Selwyn District Plan, Private Plan Change 75 – Yoursection Limited, 151 and 153 Lincoln-Rolleston Road

Joint Officer Summary Statement, Selwyn District Council

FIGURE 1: ED HILLARY DRIVE CROSS SECTION (EPA175169)

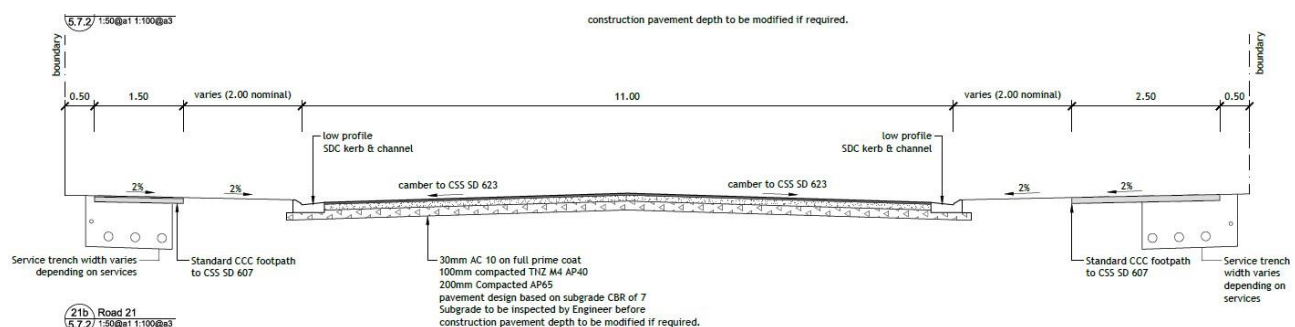
<p>iii. The ODP Plan is amended to illustrate the walking and cycling routes within the site, including the north-south and east-west cycle routes.</p>	<p>The plan change proponent has amended the ODP to address this recommendation. The "cycle route" along the alignment of the "CRETS Road" is not supported. This is because it would only provide for a "partial cycle network" and an appropriate connection has been provided on the parallel road.</p>	<div> <input type="checkbox"/> Agree <input checked="" type="checkbox"/> Neutral <input type="checkbox"/> Disagree/further comments </div> <hr/> <p>Comments - Mr. Collins, Transport</p> <p>Regarding Mr. Collins recommendation for the provision for cycling on Ed Hillary Drive (CRETS Collector), he has reproduced the approved cross sections for this road, immediately to the west of PC75 (provided as Figures 1 and 2 below). These are Engineering Plan Approval numbers 175169 and 185322. Both cross sections show a 2.5m wide shared use path on the southern side of Ed Hillary Drive.</p>

Mr. Collins anticipates that the same cross section will be provided through PPC75, and that the ODP should identify provision for cycling as has been approved to the west of PPC75.
iv. The ODP is amended to illustrate a 'double arrow' to reference future links.	The plan change proponent has amended the ODP to address this recommendation.	<input checked="" type="checkbox"/> Agree <input type="checkbox"/> Neutral <input type="checkbox"/> Disagree/further comments <hr/> No further comment required.
